ADDENDUM NO. 2

NEW BAND ROOM AND ATHLETIC FACILITIES FOR JACKSONVILLE HIGH SCHOOL Architect Job No. 22-47B December 12, 2023

|                            | AECIS N             | ERED ARCHIE |
|----------------------------|---------------------|-------------|
| LETIC FACILITIES FOR<br>OL | PROJECT NO.         | ASD2.1      |

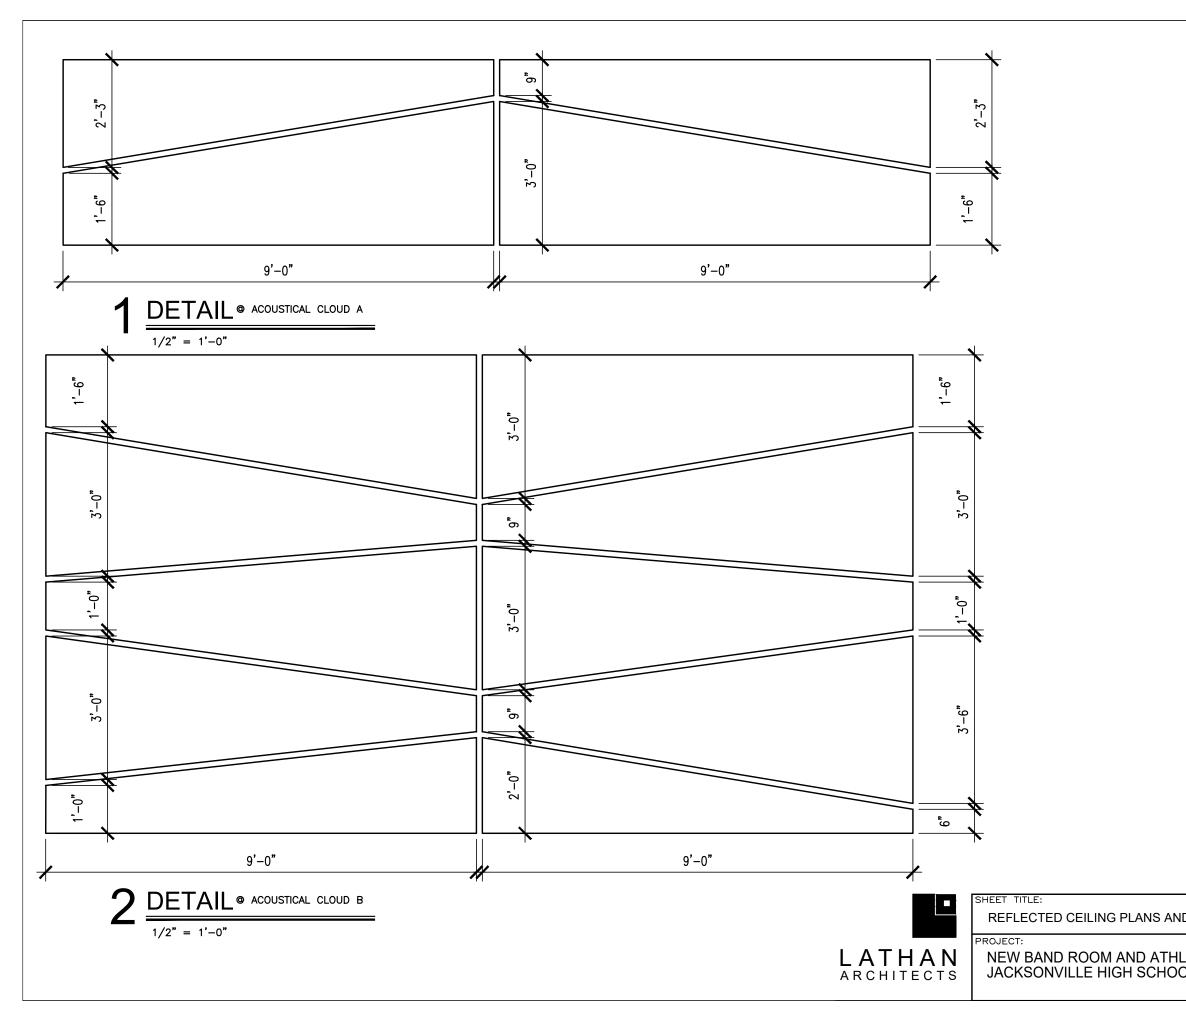
1. Refer to ASD2.1-ASD2.4 for dimensions of acoustical ceiling clouds.
